MSOS254A-03D

Modification Recommended Service Note

MSOS254A – MSO Infiniium S Series 2.5GHz 4 channel

The Problem – Under certain circumstances a PLL2 error may occur on the S-series products.

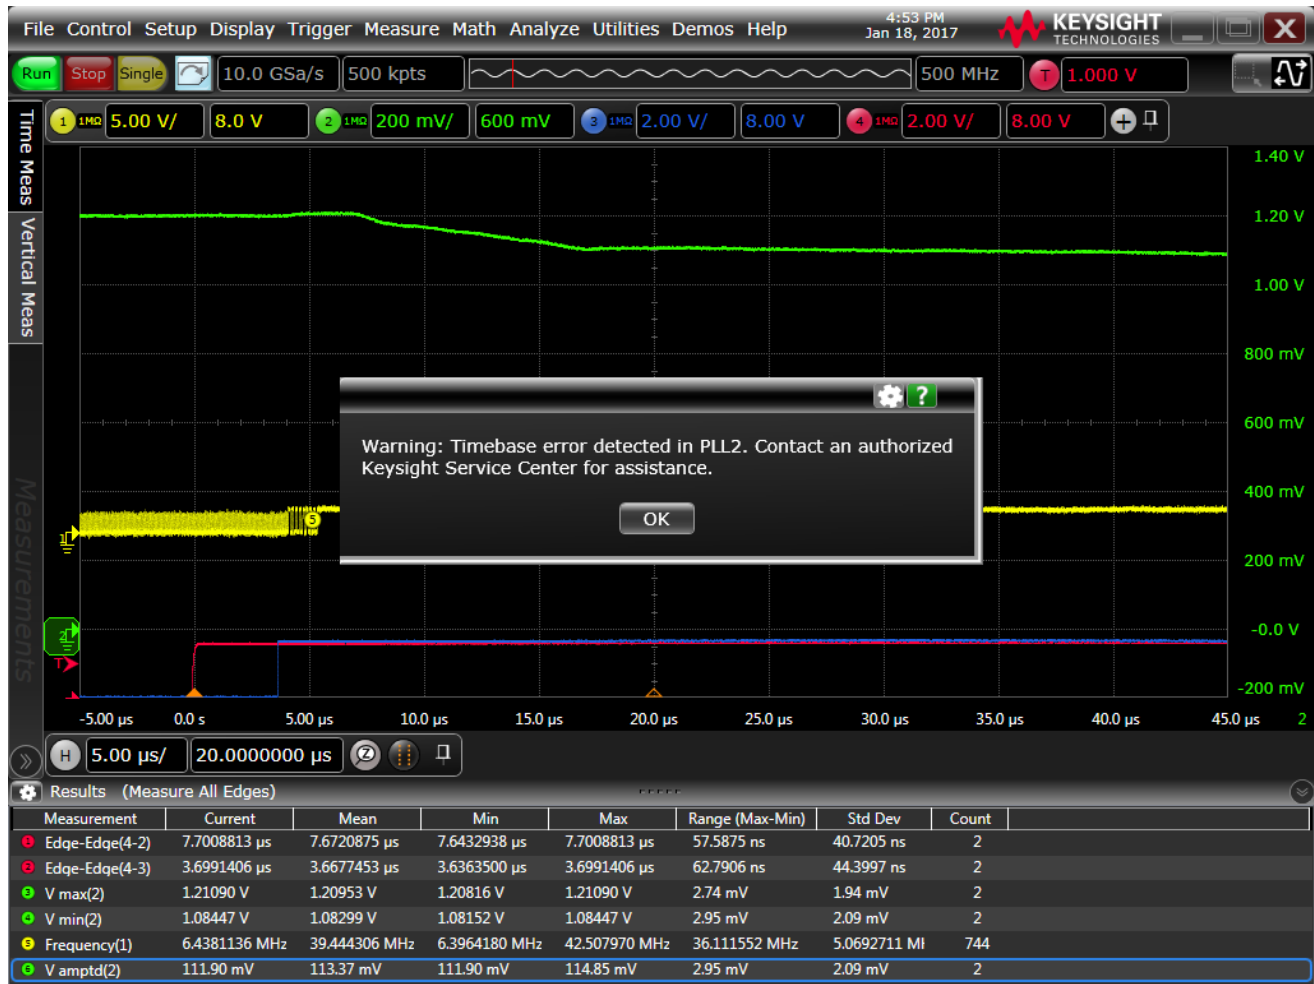
On older acquisition boards a PLL2 error message sometimes occurs. The error message appears on the screen as below:

There are new acquisition boards that fix this issue for the S-series scopes.

Please, use the 54911-69511 board until is gone.

1. If the customer needs to have software revision < 6.10.01001, then replace the acquisition board with the 54911-69532 board.
2. If the customer can have software revision >= 6.10.01001, then it can be replaced by any of these three boards: 54911-69521, 54911-69531, or 54911-69532.
3. Save the Serial Numbers of the replaced and the new Acquisition Boards in Siebel. Please, follow this procedure:
 - a. For each Service Order in Siebel, there is a tab labeled Activities:
